DEVELOPMENT APPLICATION ASSESSMENT REPORT

Application Number:	DA2023/1747
Responsible Officer:	Anaiis Sarkissian
Land to be developed (Address):	Lot 42 DP 228171, 3 Arrabri Place WARRIEWOOD NSW 2102
Proposed Development:	Alterations and additions to a dwelling house including a swimming pool
Zoning:	C4 Environmental Living
Development Permissible:	Yes
Existing Use Rights:	No
Consent Authority:	Northern Beaches Council
Land and Environment Court Action:	No
Owner:	Robert Ipscwitz
	Bianca Leanne Ipscwitz
Applicant:	Bianca Leanne Ipscwitz

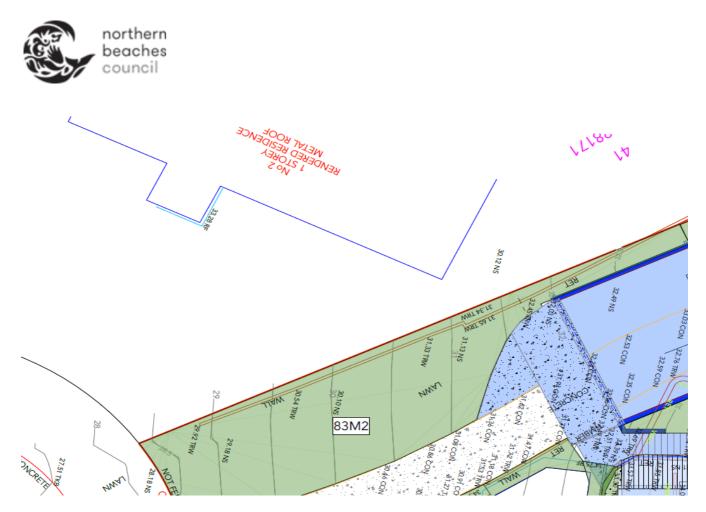
The proposed carport is set back 0.9m from the western side boundary, representing a 64% variation to the minimum standard of 2.5m.

It is important to note that the side setback to the proposed rumpus room and main dwelling is 3.6m. The south-western boundary is also screened by dense vegetation and high hedges, as evident in the

site photo below, minimising potential amenity impacts for the adjoining property. The carport structure is non-habitable and therefore privacy impacts are not a major issue.
